CONSTRUCTION PLANS
FOR
SKYLINE AT LORSON RANCH FILING NO. 1
STREET AND STORM SEWER
CONSTRUCTION PLANS

SKYLINE AT LORSON RANCH FIL. NO. 1
STREET AND STORM SEWER
CONSTRUCTION PLANS

SHEET NUMBER
C6.1

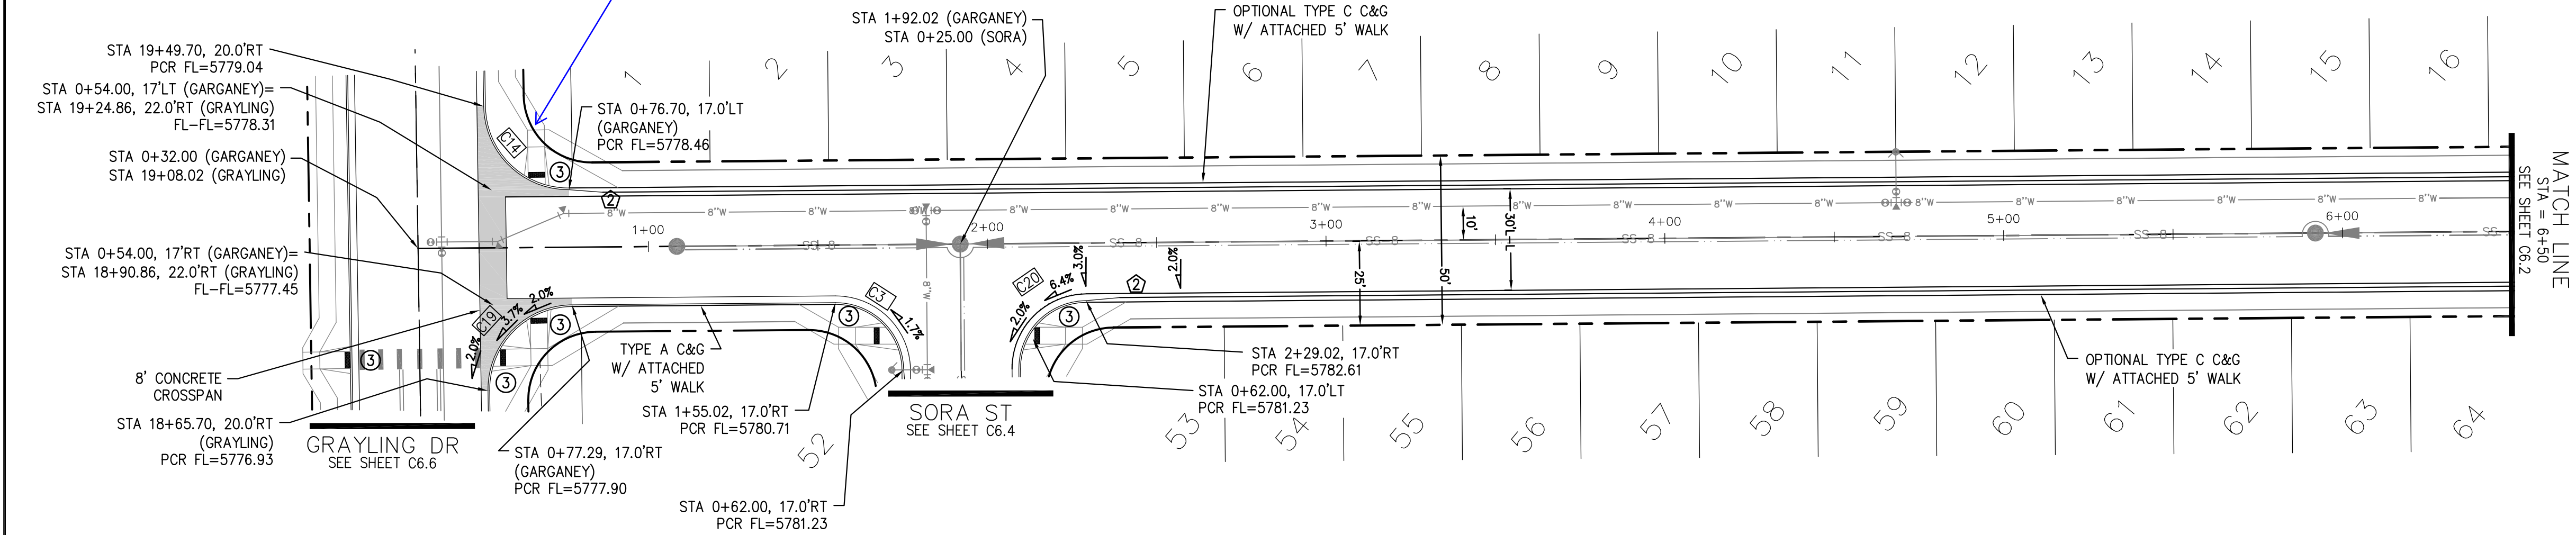
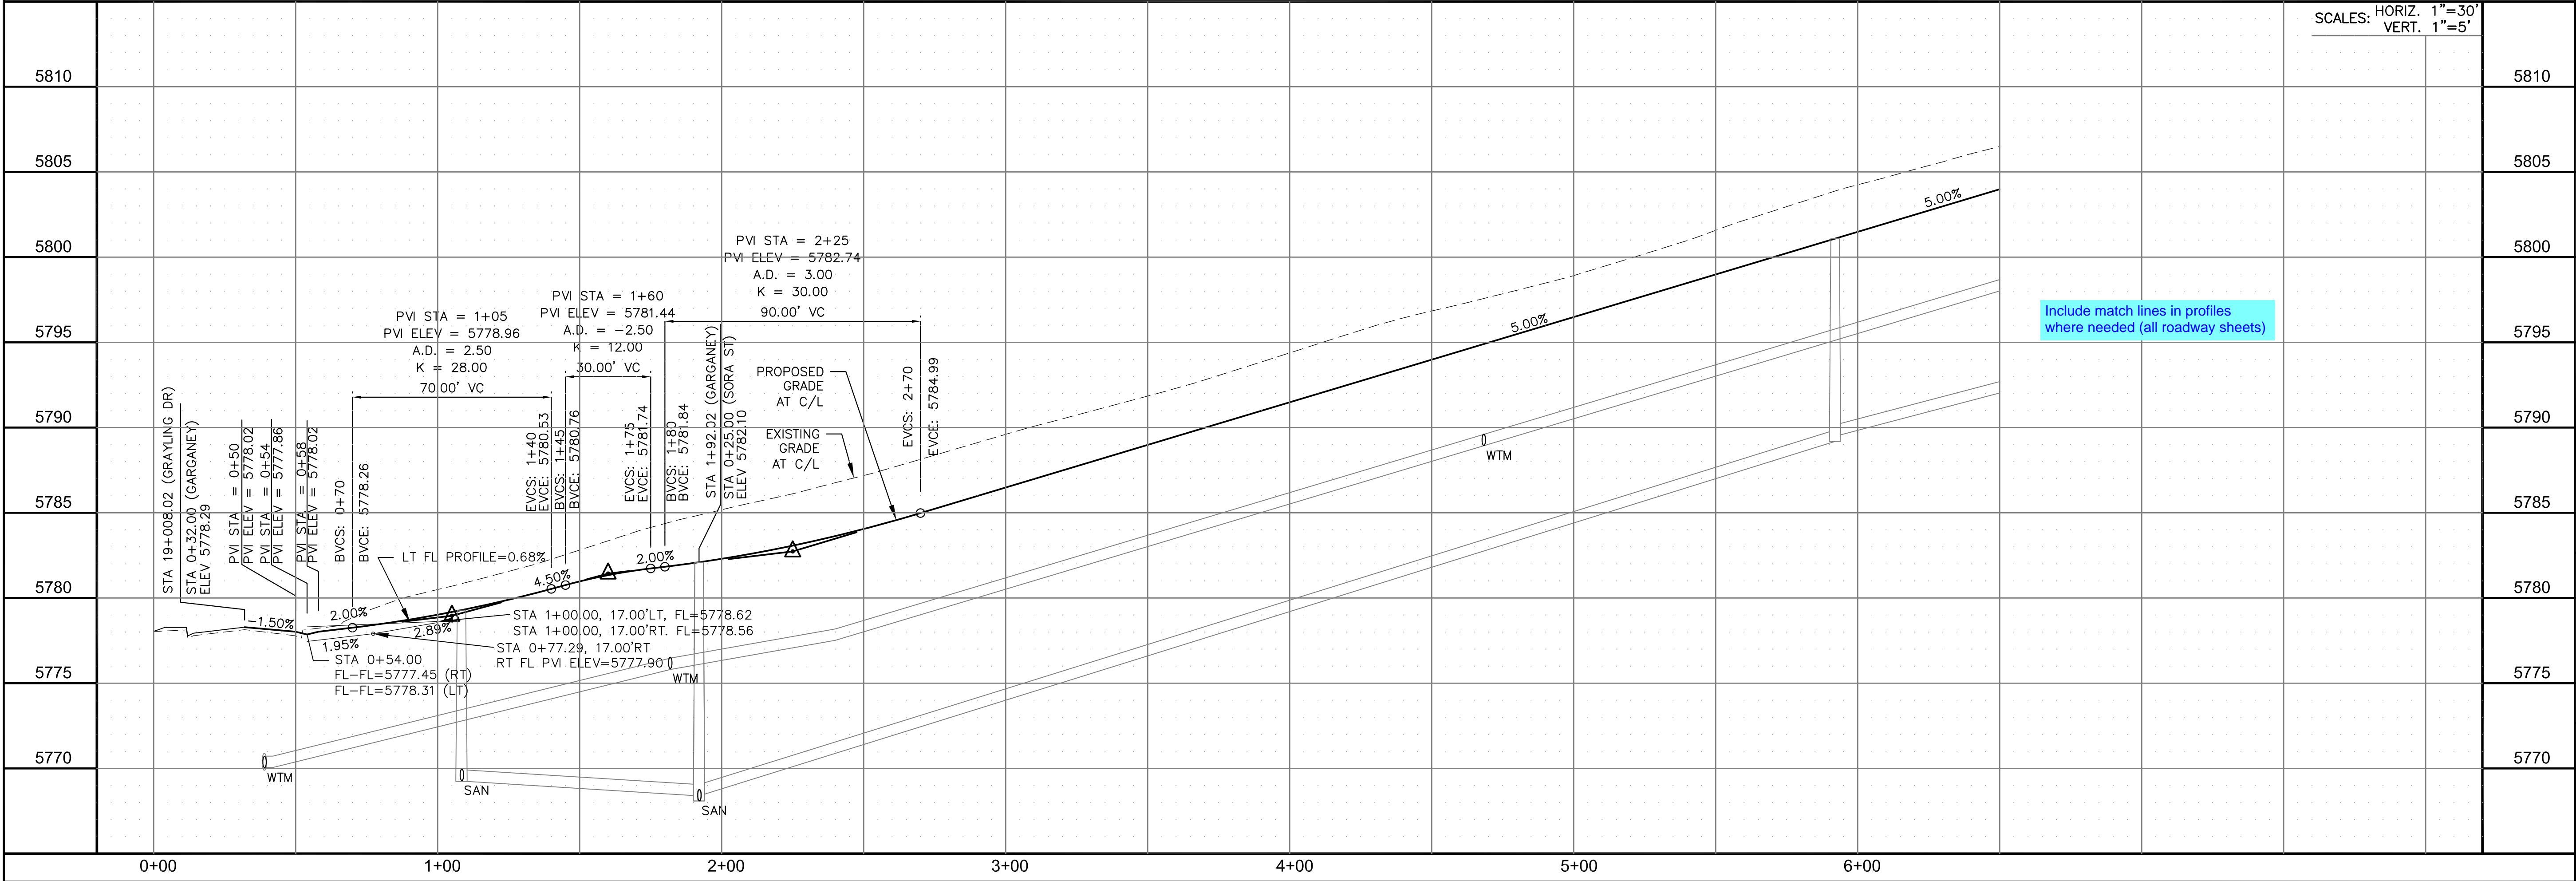
Include line information for alignment
line segments (all roadway sheets)

STREET - STORM
GARGANEY DRIVE
STA 0+00 TO 6+50

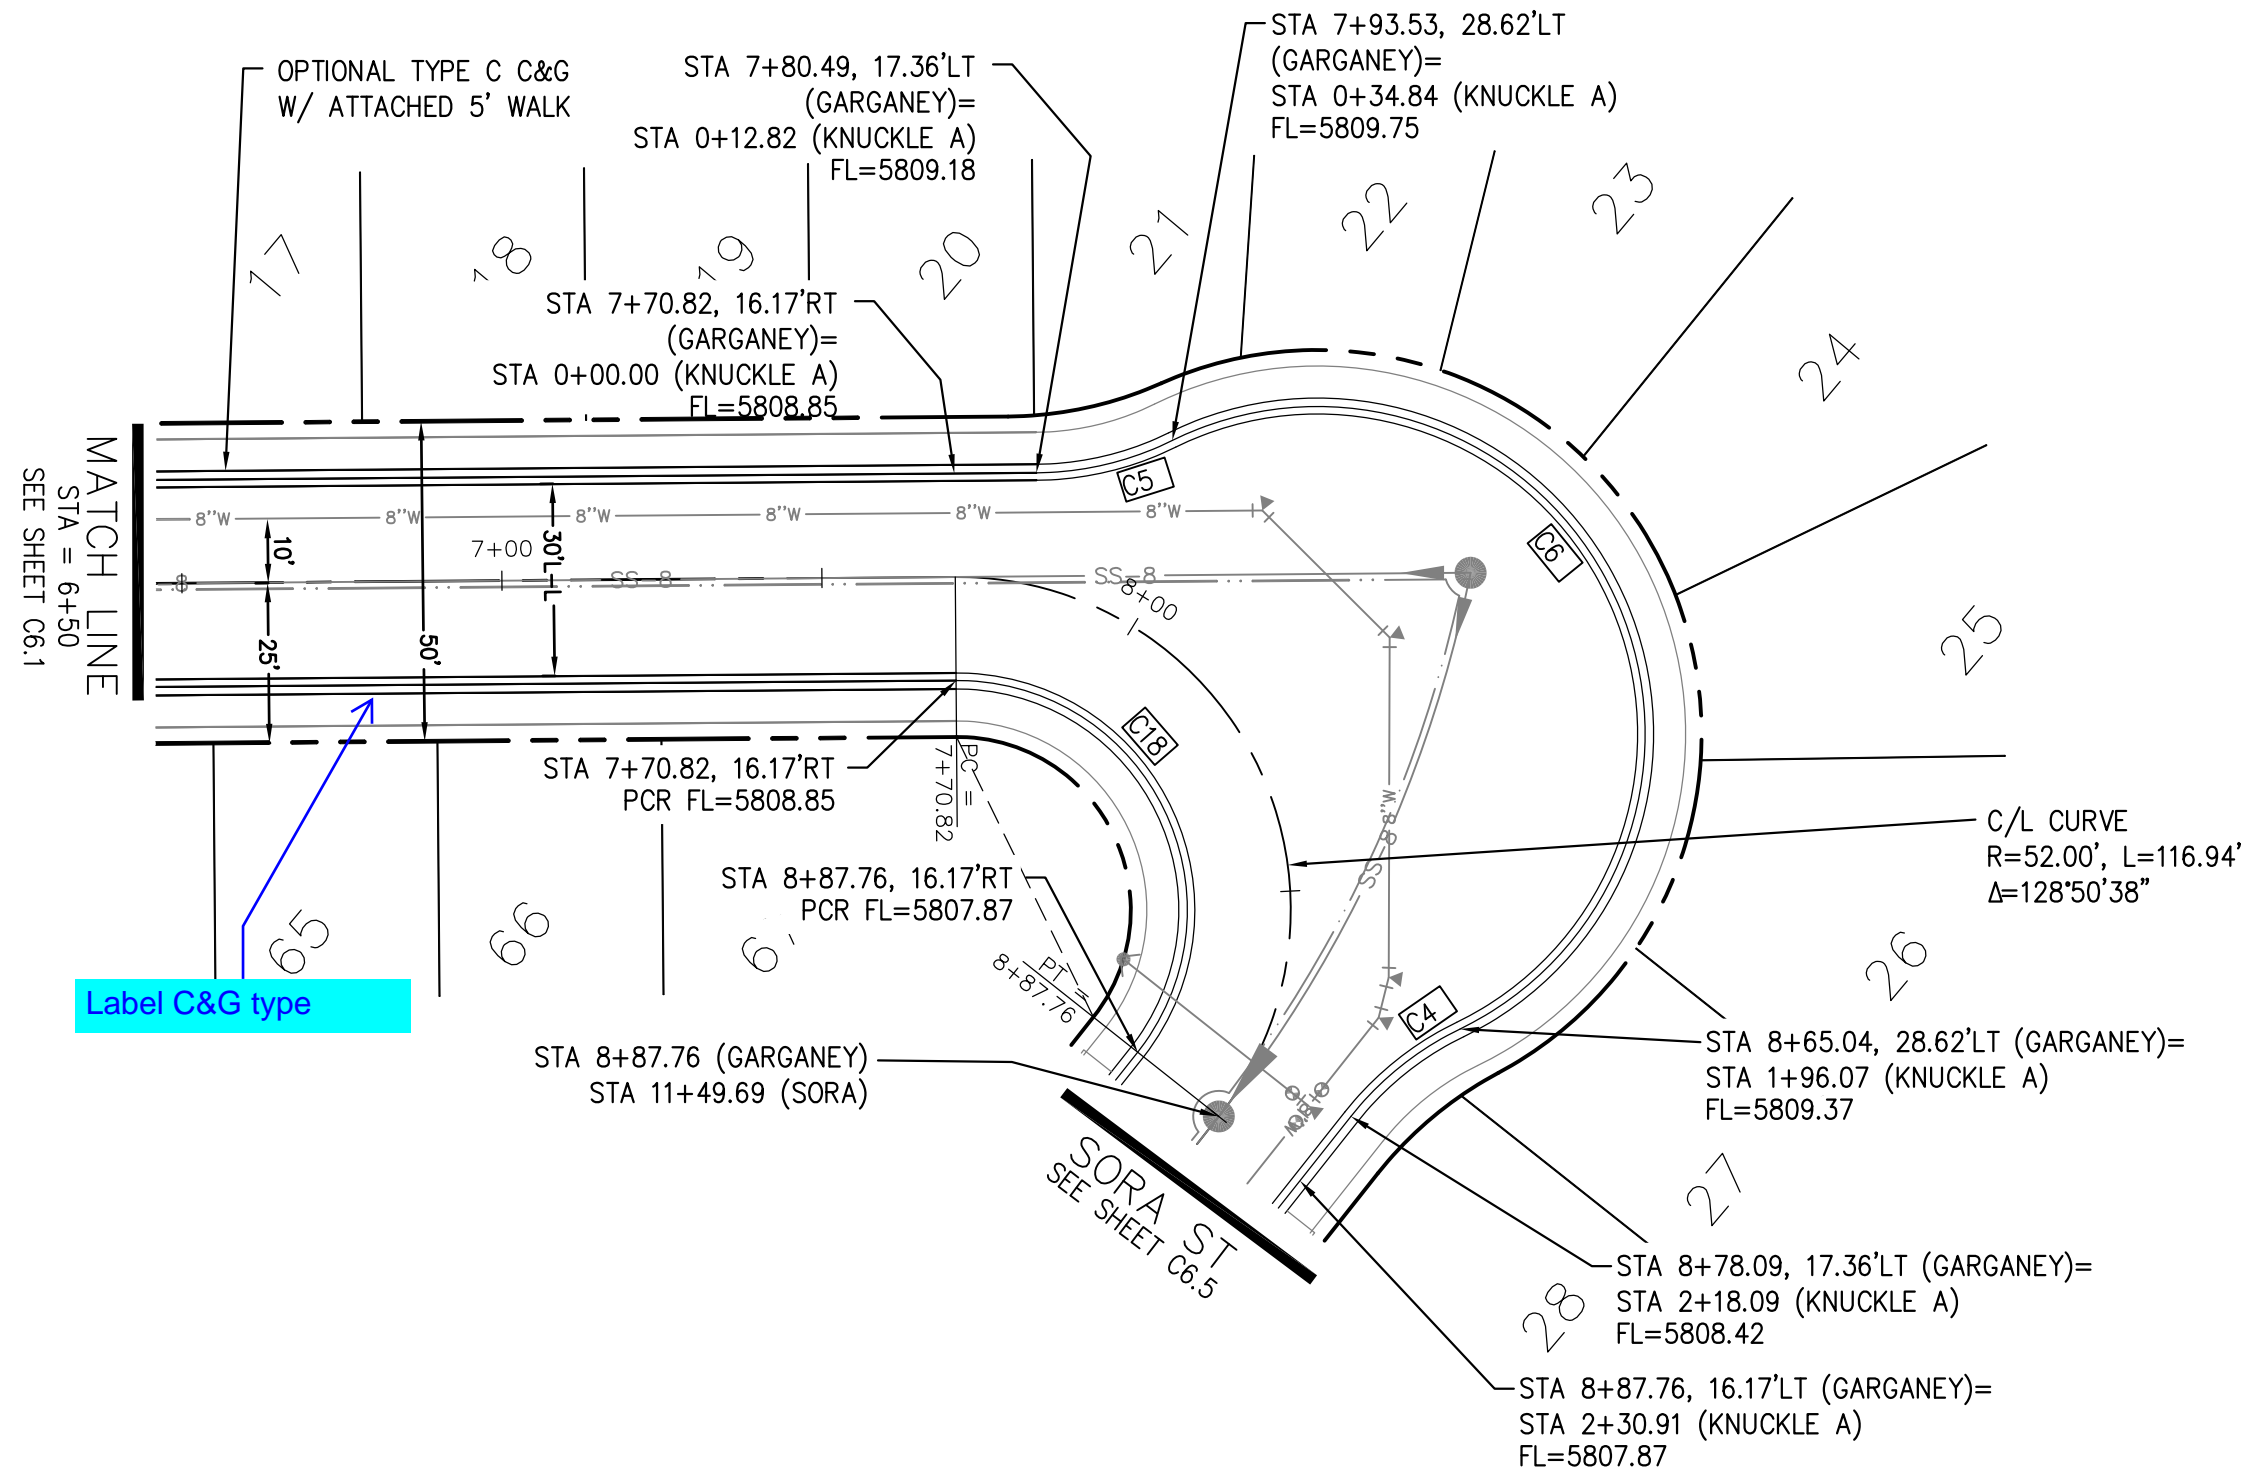
Include match lines in profiles
where needed (all roadway sheets)
